ADDENDUM #1 TO BID #19-077

PROCUREMENT FOR: Waccamaw Library Parking Project

WACCAMAW LIBRARY-PARKING LOT EXPANSION
 GEORGETOWN COUNTY, SOUTH CAROLINA

SCALE: 1:30
 DESIGNED BY: ASB
 DRAWN BY: MPM
 DATE: 9/13/2019
 SITE PLAN
 SHEET NO: C-04

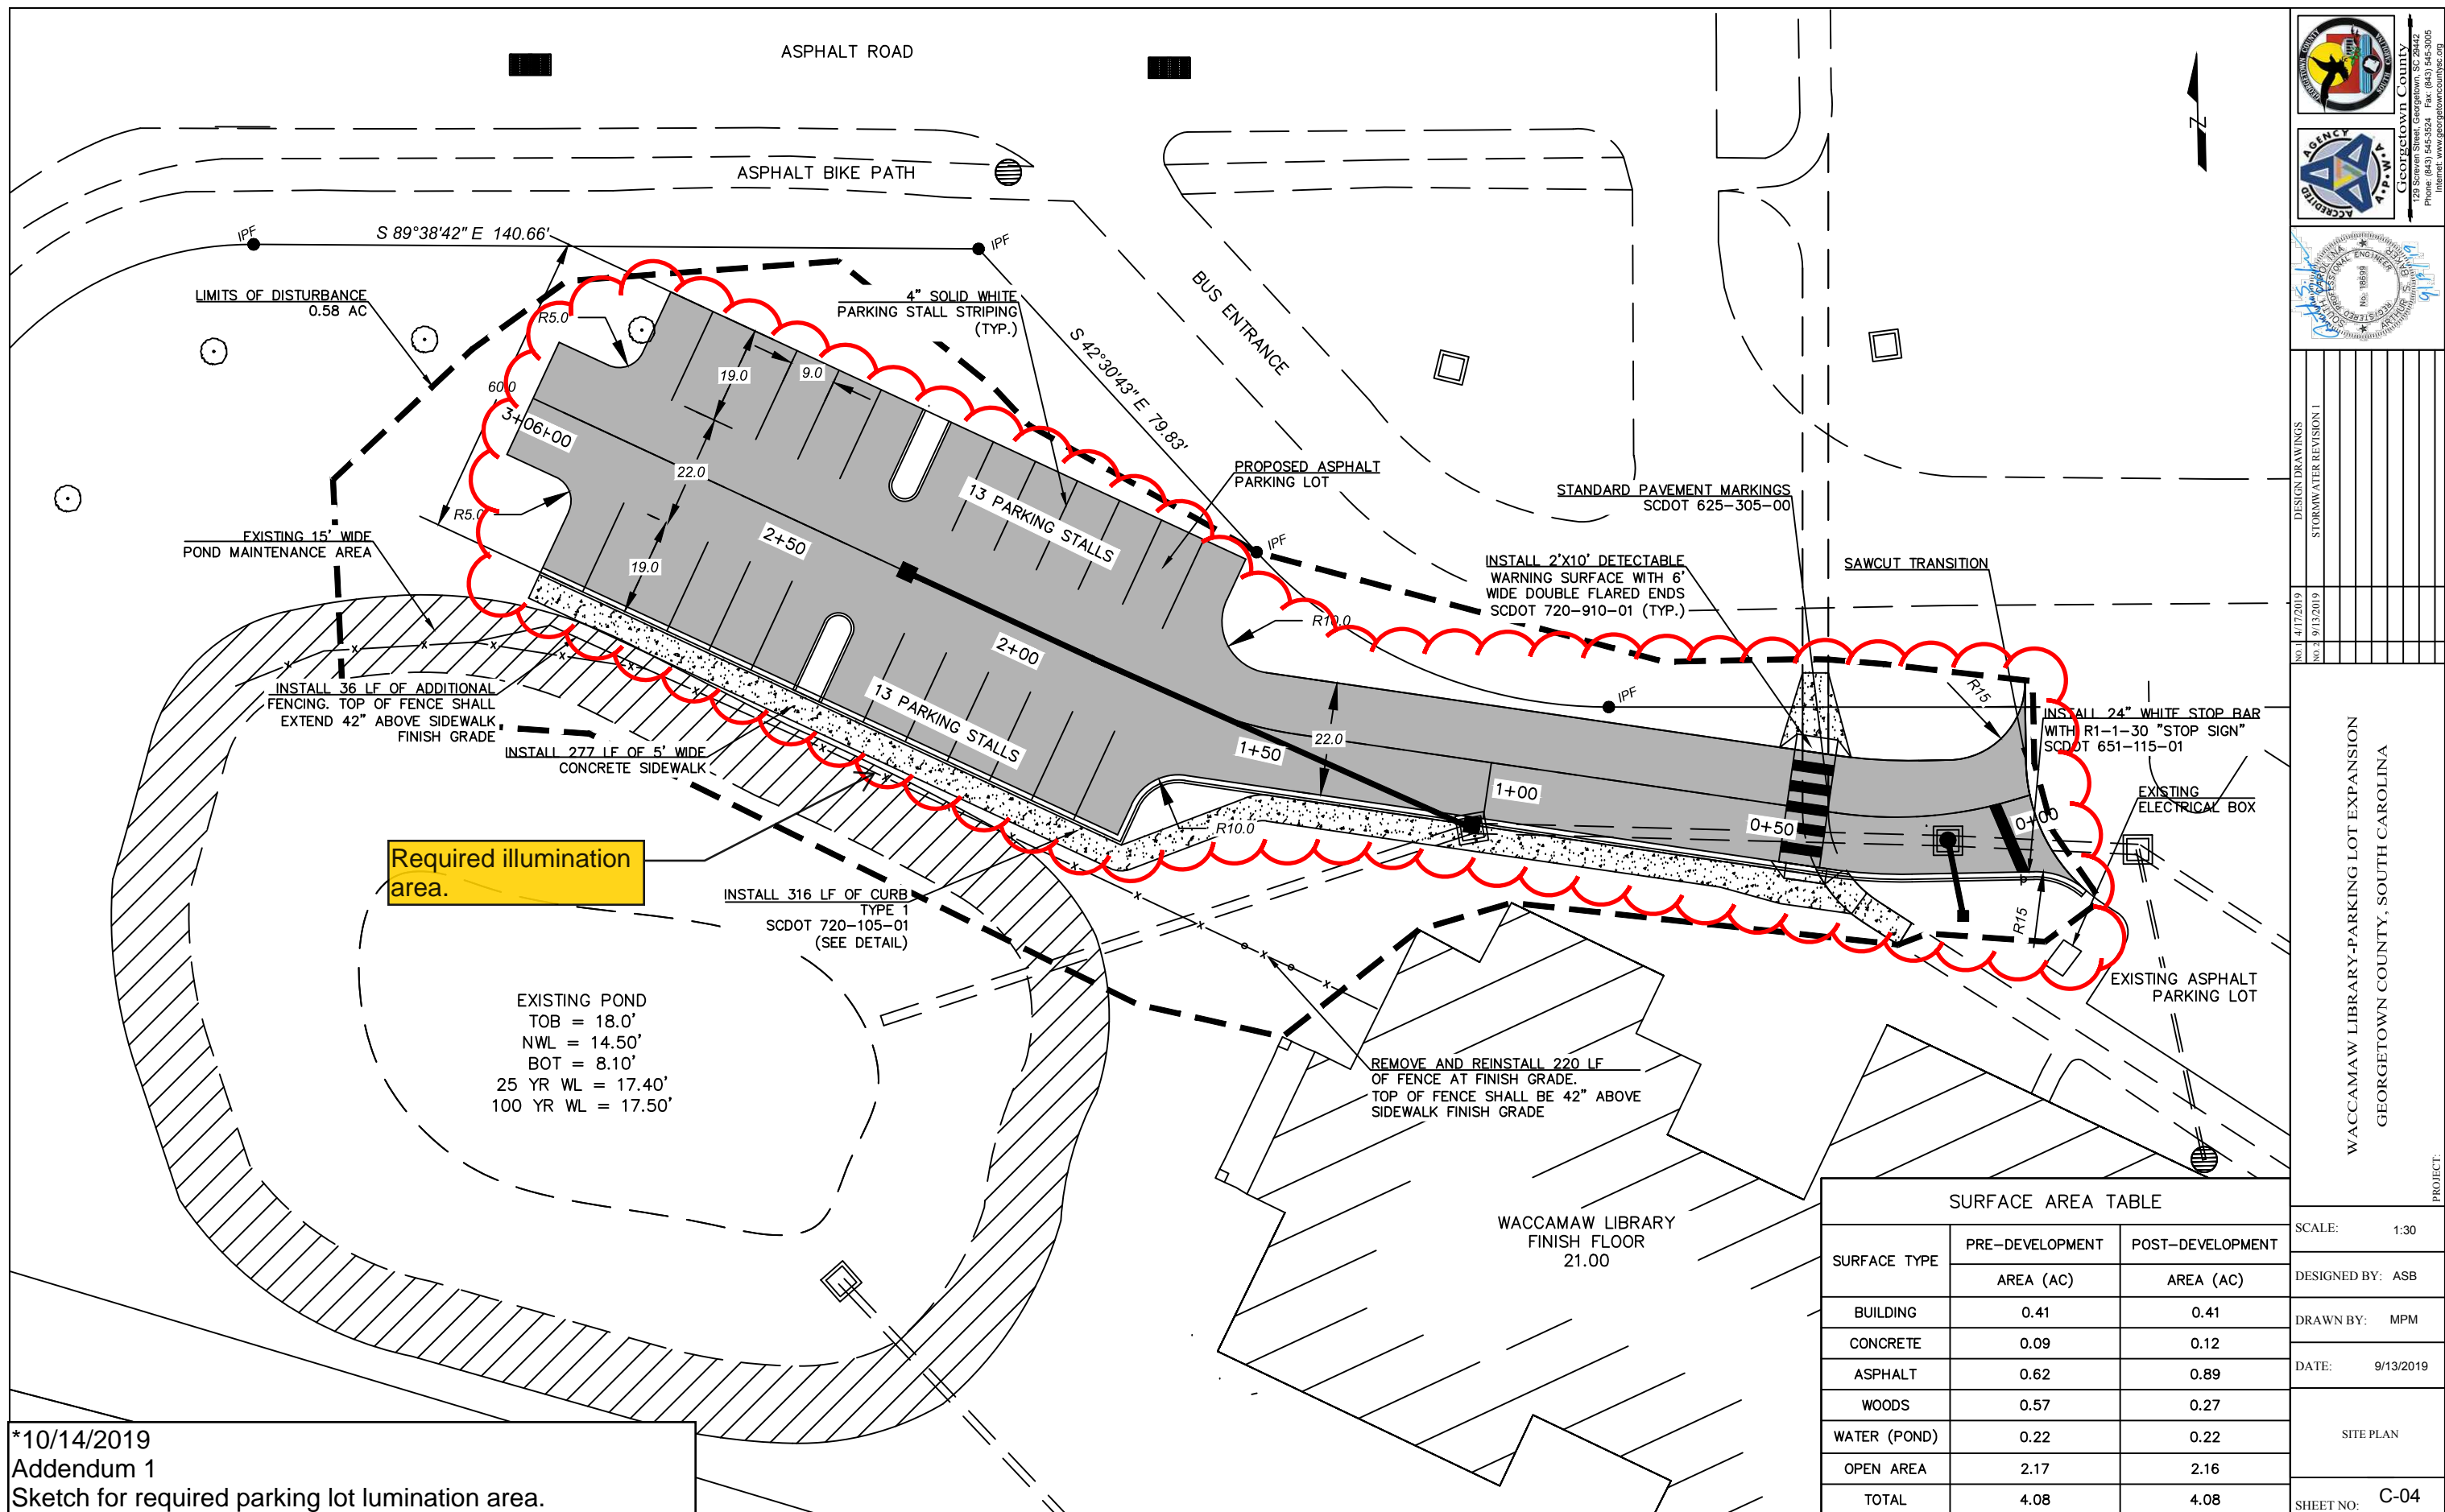
On the Unit Price Schedule in Exhibit H there is an item listed as “#31 Parking Lot Lighting – 1 LS”, but there are not any references to any electrical items or lighting on the design plans. Nor is there any spec in the proposal book for this. Please advise whether or not this will be part of the project. If so, please provide design plans to enable us to provide pricing.

Answer 1: Please see attached drawing

1. The parking lot lighting will be a design-build item.
2. Please see the attached Parking Lot Illumination Map showing the area to be illuminated.
3. The contractor will be responsible for all lighting requirements such as:
 - a. Light pole/fixture installation
 - i. With concrete base as required
 - ii. Light pole/fixtures shall match existing parking lot lighting on site
 - iii. Flood light mounted to building may be utilized for sidewalk lamination
 - b. Underground electrical conduit
 - c. Connection to existing electrical panel inside the building.
 - i. Integration with existing parking lot lighting control (on/off/photocell)
 - d. Meet requirements of the IESNA Lighting Handbook requirements to include (but not limited to):
 - i. Horizontal/Vertical Illuminance
 - ii. Uniformity Criterion

Required illumination area.

*10/14/2019
 Addendum 1
 Sketch for required parking lot lumination area.
